BLUE RIVER PLANNING AND ZONING COMMISSION MEETING

TO: Town Manager/Clerk
FROM: Kyle Parag, Plan Reviewer - CAA
DATE: April 21, 2026 – **NOTES IN RED FROM TOWN MANAGER (May 27, 2026)**
RE: Planning/Zoning/Architectural Guidelines review – 103 Blue Rock

GISKE GARAGE

TO: Chad Hull-Town Manager
FROM: Kyle Parag, Plan Reviewer - CAA
DATE: May 27, 2026
RE: Planning/Zoning/Architectural Guidelines review – 0066 Conifer

SHEET:
A-1
PLOT PLAN

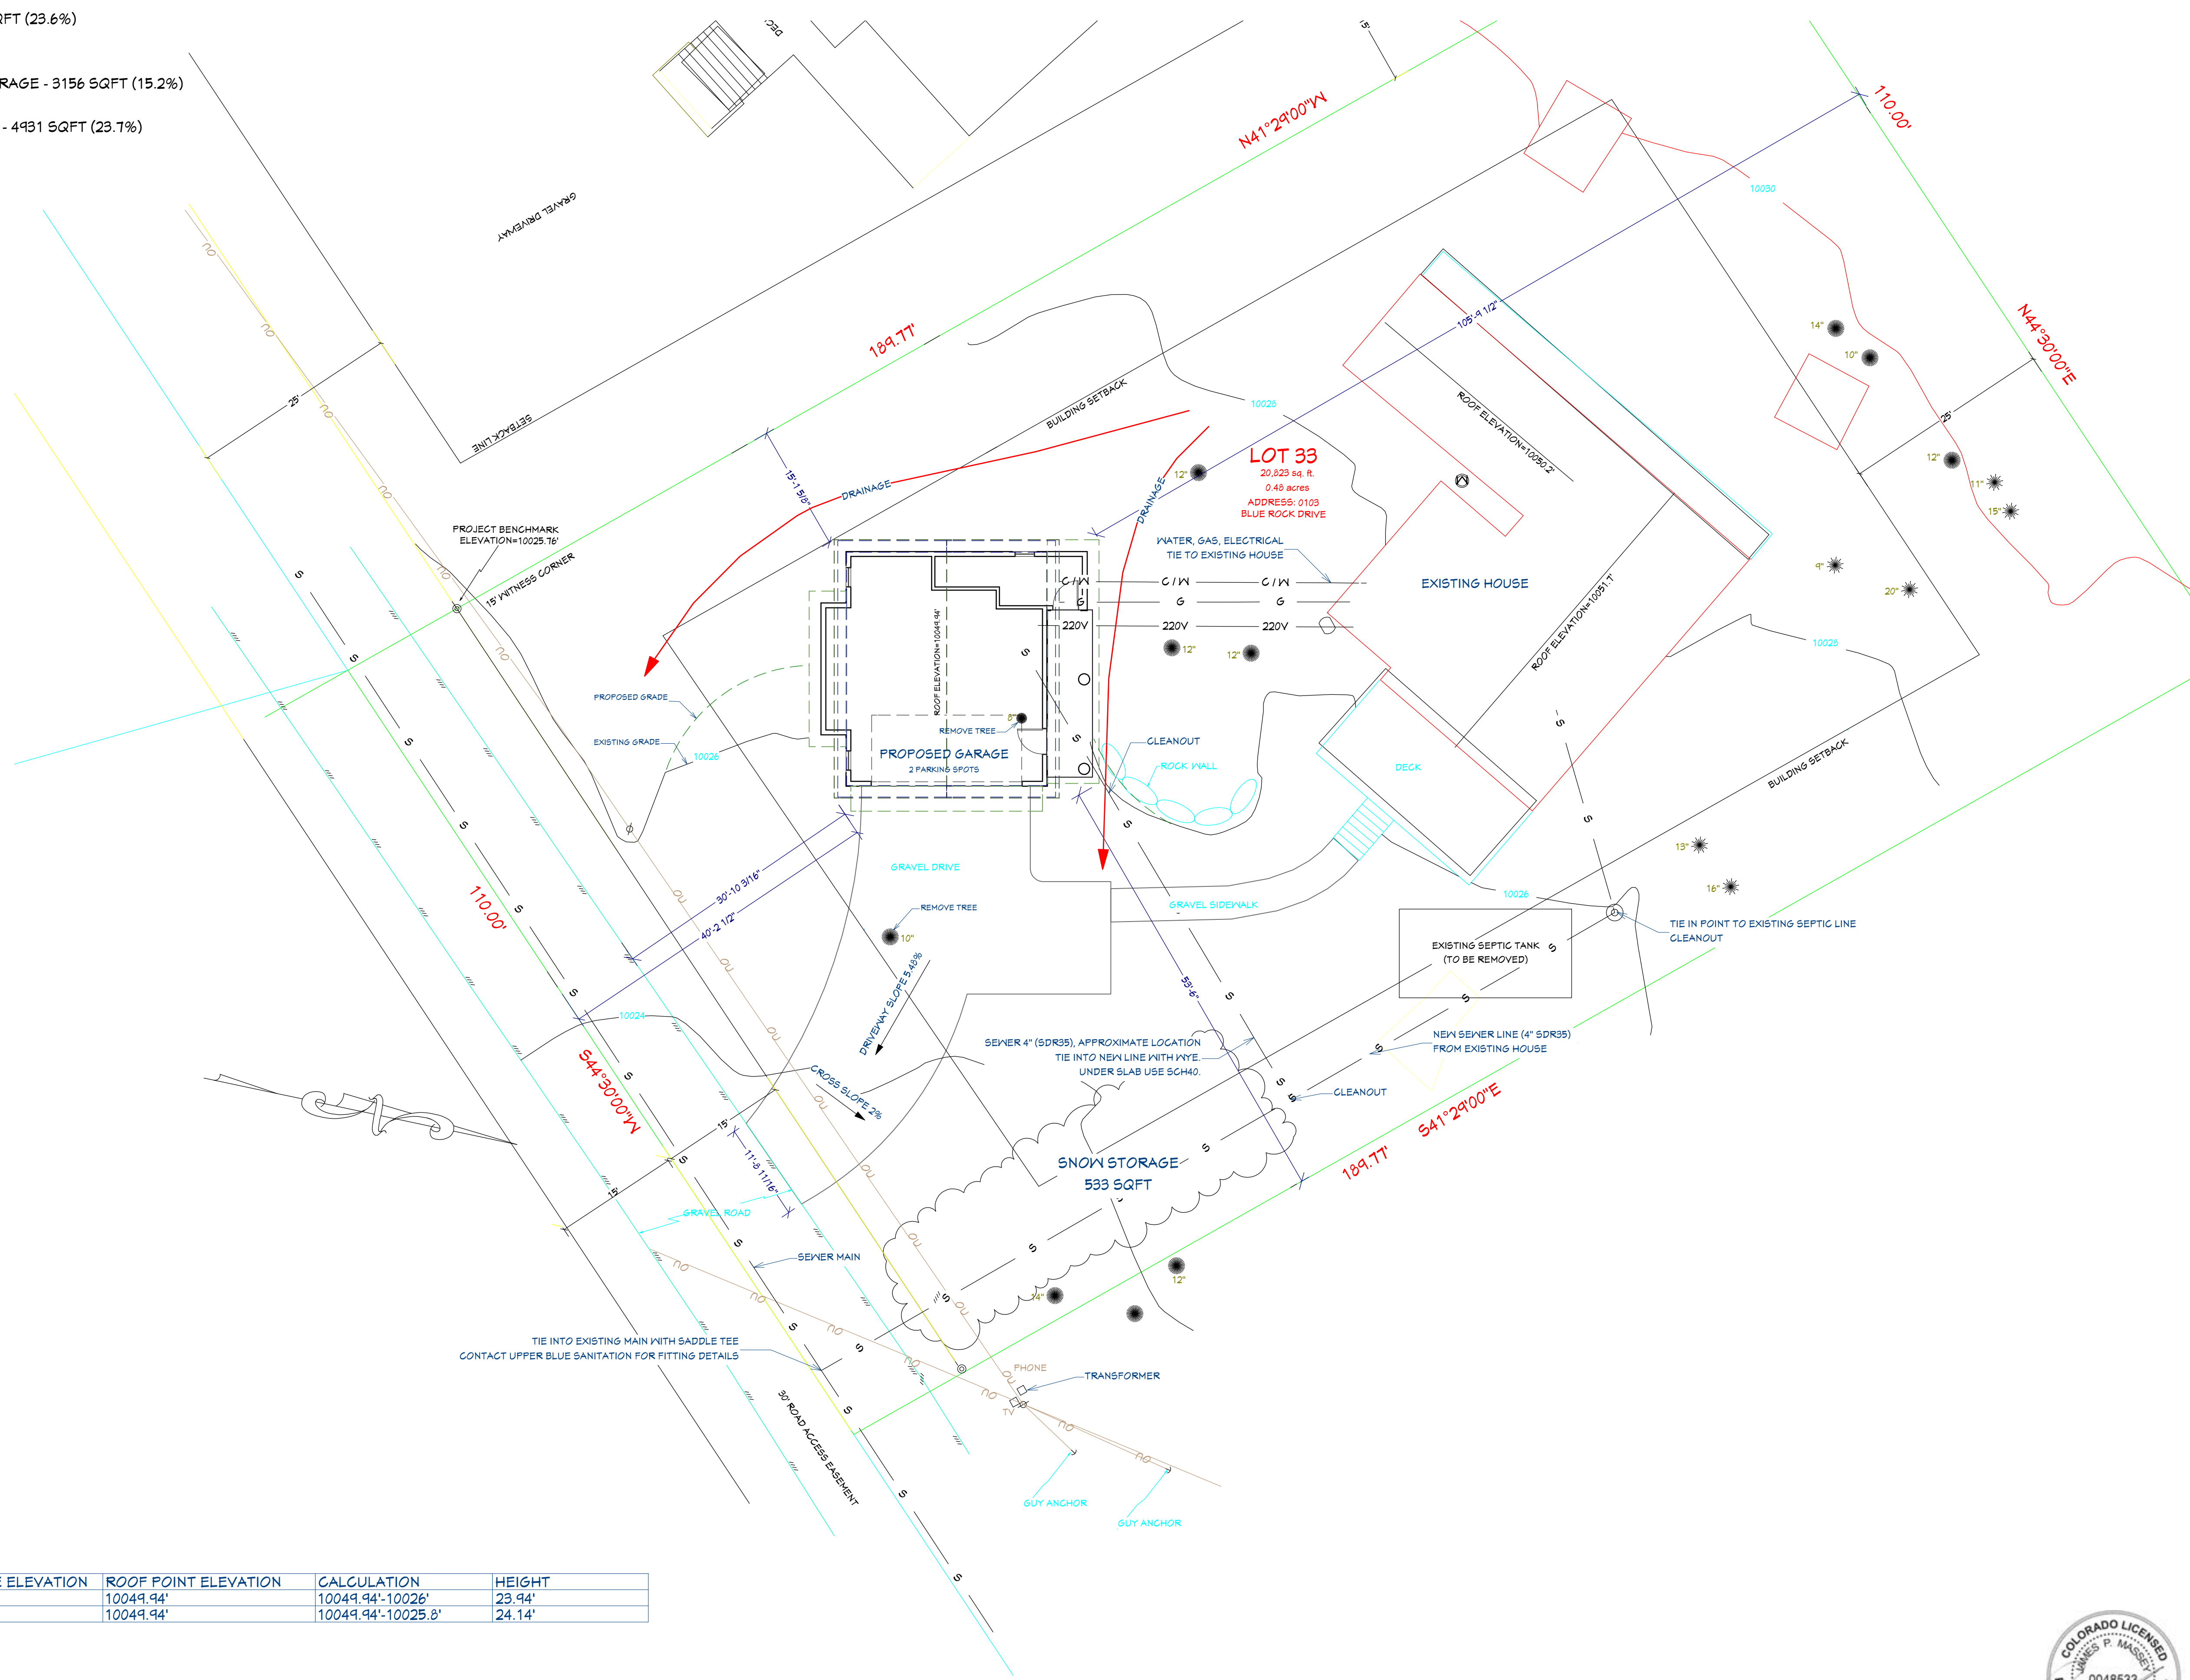
Setbacks: Proposed garage structure does not comply with front setback requirements to measure from the existing road location. Measured from easement.
Revised plans submitted on 5/27 claiming compliance with setback requirements.

STANDARD	NOTES/REMARKS	SUBSTANTIAL COMPLIANCE
DEVELOPMENT STANDARD		
Article 3: Easements	Easements are indicated	Y
Article 4: Buildable Area/setbacks	Front setback is measured incorrectly, garage sits in the front setback by about 4' Revised plans display garage within buildable envelope.	N
Article 5 Building Design Standards		
Article 5-20 Building Height	Height is indicated at 23'10" Does not appear to comply with 16B-7-30 (d) Revised plans indicate subordinate height of garage relative to primary structure.	N
Article 5-60 Foundation	Foundation is indicated as exposed concrete	N
Article 5-70 Roofs	Main roof design is a gable roof with a slope of 5:12	Y

Article 5-80 Garages	Garage door has a contemporary design. Project does not comply with 16B-5-80 for the garage being set back from the front walls of the main structure.	N
Article 5-90 Window and doors	Shows general conformance	Y
Article 5-100 Balconies and railings	None indicated	Y
Article 5-110 Chimney and Roof Penetrations	None indicated.	Y
Article 6 Building Materials and Colors		
Article 6-20 Materials	No color board was provided, assumed to match existing home as required, image of home provided with shake siding look.	PC
Article 6-30 Colors	Colors are not provided.	PC
Article 7 Accessory Improvements		
Article 7-(20-40, 110) Berms, Garages, sheds and Gazebos	None indicated.	Y
Article 7-50 Driveways	Width indicated at nearly 40'. Slopes are minimal. Driveway to be relocated Revised plans redesigned the driveway to claim compliance with Land Use Code.	N
Article 7-60 Parking Areas	Parking areas not located, assumed interior new garage and a third spot could not be located outside of the setbacks Revised plans indicate presence of parking. Two parking spaces in the proposed garage – possible question on third parking spot on driveway.	N

A-1

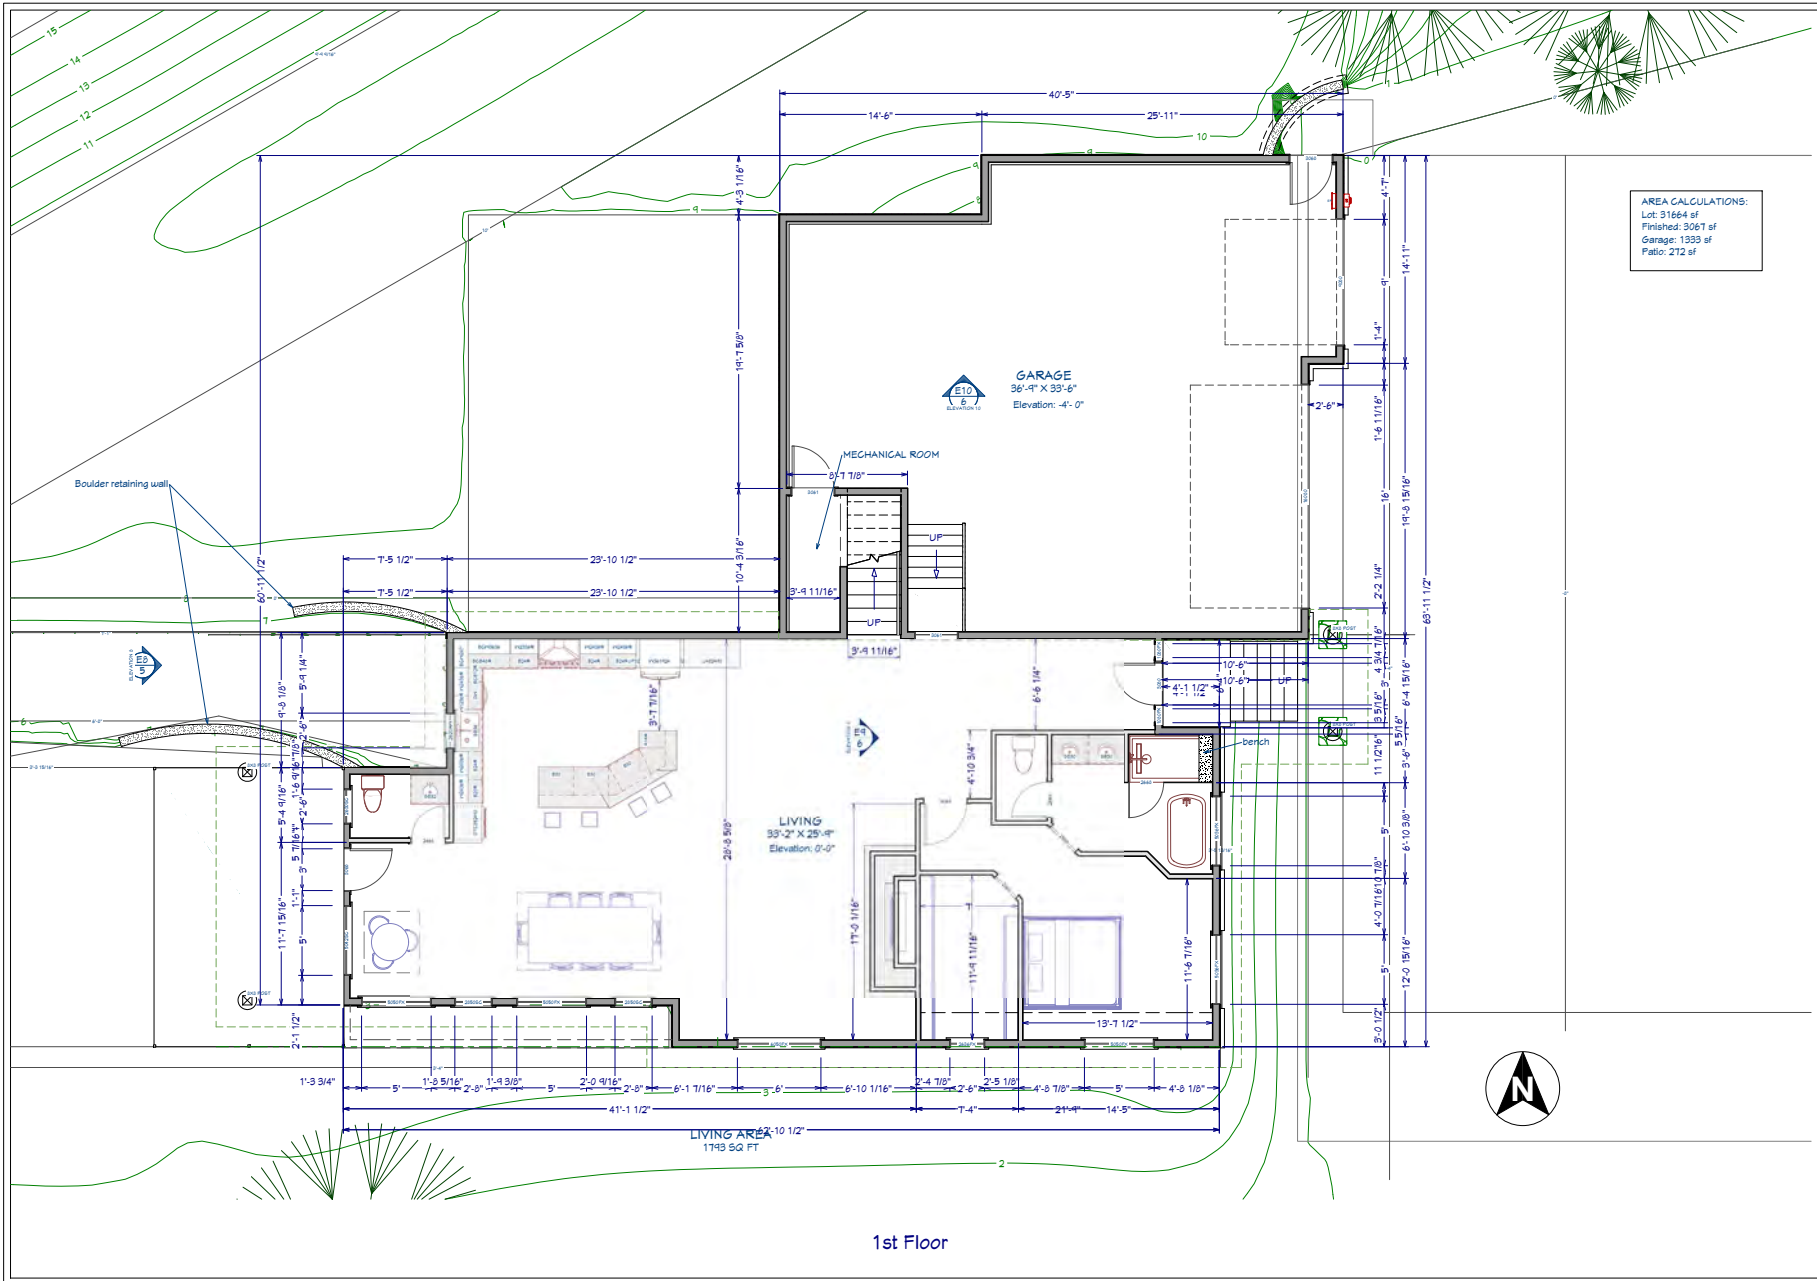
Article 5-70 Roofs	Main roof design is a shed roof, with an indicated slope of 3:12	PC
Article 5-80 Garages	Garage door has a traditional design but is partially set in front of the main walls of the home.	PC
Article 5-90 Window and doors	Windows are sized to complement the home.	Y
Article 5-100 Balconies and railings	None indicated	Y
Article 5-110 Chimney and Roof Penetrations	None indicated, but a fireplace is indicated on the floor plan	Y
Article 6 Building Materials and Colors		
Article 6-20 Materials	Siding: Charcoal metal board and batt from delta metals Masonry: Dry stack farmers mix with gray undertones. Unclear on material selection, Metal siding is conditional. No clear color board provided for appearance	Y
Article 6-30 Colors	No Color Board provided	N
Article 7 Accessory Improvements		
Article 7-(20-40, 110) Berms, Garages, sheds and Gazebos	None indicated. Garage is indicated at 1333 Sqft	Y

- ③ SHOWS ON A-1 SIDING / ROCK VENEER ON NUDURA
- ④ WILL PROVIDE, A COLOR BOARD ON 6/2 TUESDAY
- ⑤ GARAGE BEING PARTIALLY IN FRONT OF THE MAIN WALLS OF THE HOME PER 16B-5-80. SEEMS NOT APPLIABLE BECAUSE THIS IS AN ATTACHED GARAGE, SIMILAR TO MOST ~~DEVELOPMENTS~~ DEVELOPMENTS IN BLUE RIVER, 16-20-70 / 16B-7-60 16B-7-150.

TOWN OF BLUE RIVER, COLORADO
PLOT AND EC PLAN

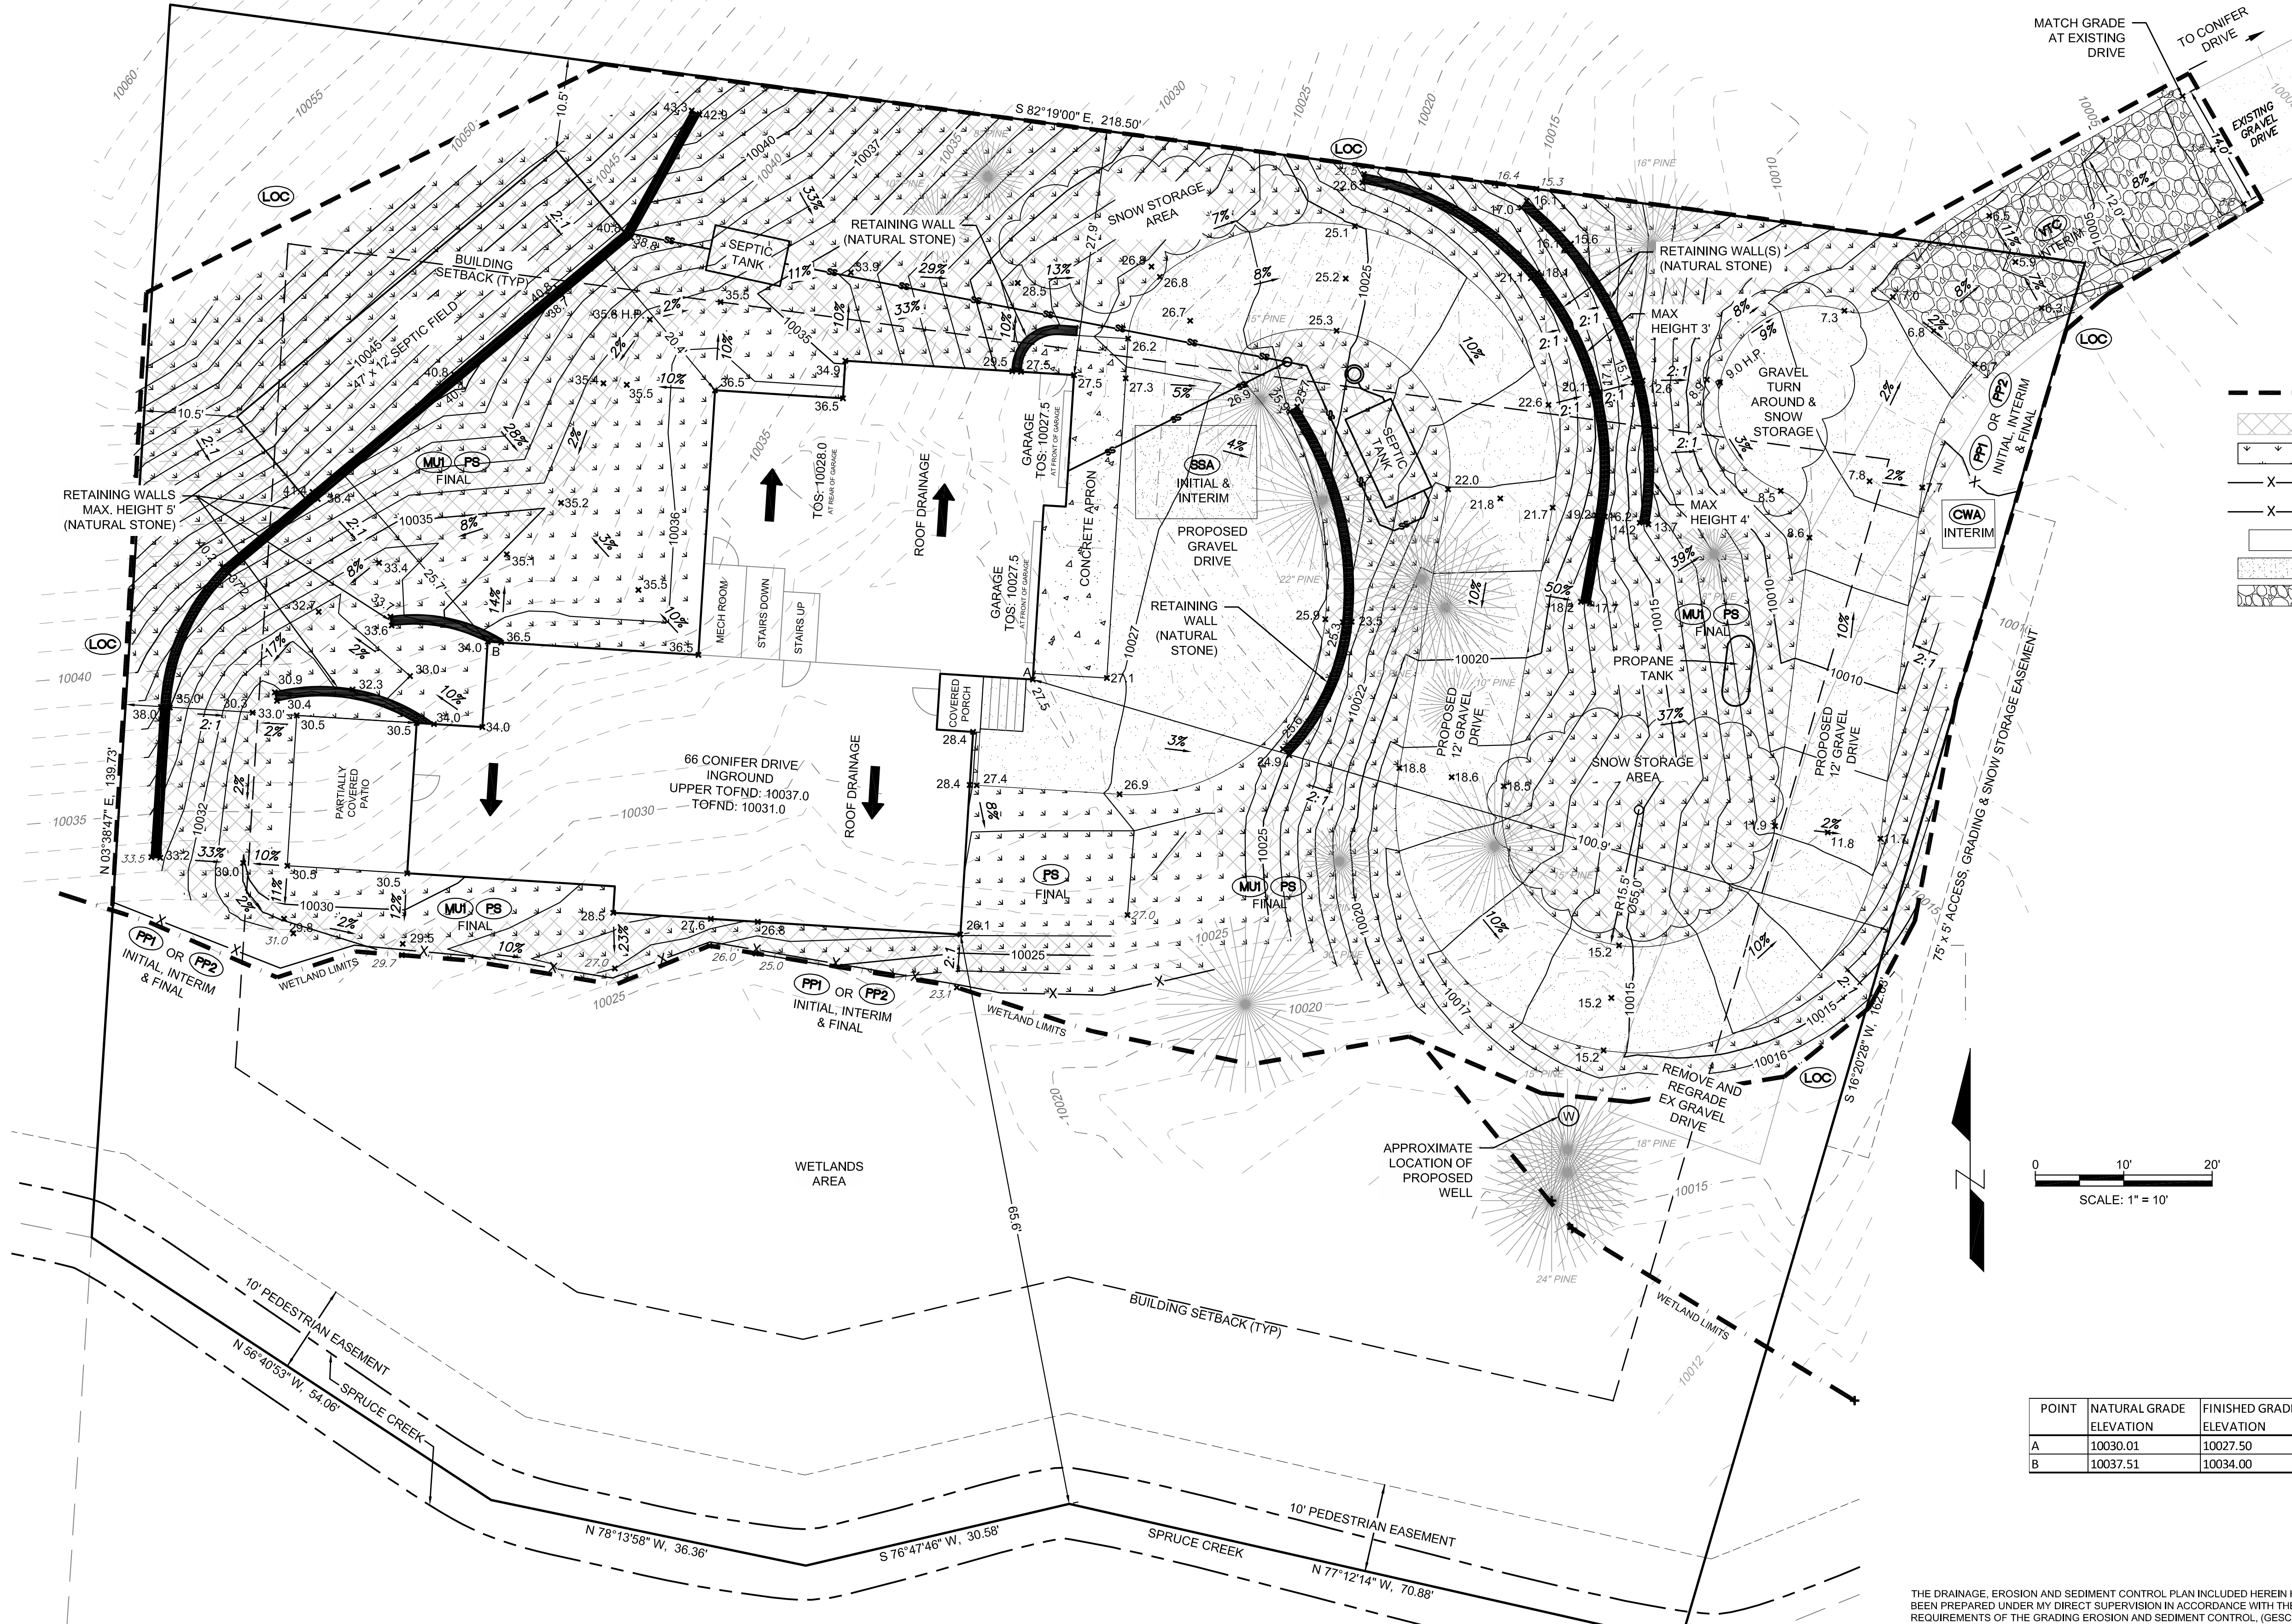
Setbacks: Proposed principal residence complies with required setbacks based upon submitted docs. Front cannot be definitively determined, and up to the Planning and Zoning committee interpretation. The entry point is mostly on the north side, however the house orientation is mostly facing east. The provided site plan indicates the front setback is the north, and therefore the rear is south. If the orientation to turned, the patio is located 20' from the property line and is in the setback, but the roof overhang does not appear to. The scaling is incorrect on the drawings to validate a distance.

STANDARD	NOTES/REMARKS	SUBSTANTIAL COMPLIANCE
DEVELOPMENT STANDARD		
Article 3: Easements	Easements are indicated. Pedestrian easement is along southern edge.	Y
Article 4: Buildable Area/setbacks	Setbacks are indicated with the orientation issue as listed above. Site plan DOES NOT indicate the roof planes, and the north wall is indicated at 2'10" from the setback line, overhangs are indicated at 24"	PC
Article 5 Building Design Standards		
Article 5-20 Building Height	Height is indicated at 26'-2"	Y
Article 5-60 Foundation	Foundation covering is not indicated	N

- ① SET BACKS : PLAN CLEARLY SHOW EAST AS FRONT ~~OF~~ REAR IS 25.5 TO EDGE OF DRIPLINE KYLE HAS MEASURED TO EDGE OF CONCRETE FOR 20' THIS IS NOT COVERED BY ROOF, ONLY PARTIAL AS STATED ON SITEMAP. (ENTRY POINT IS NOT NORTHSIDE)
YOU ARE CORRECT W/SCALE ON ARCH / REFER TO S-1 CORRECT
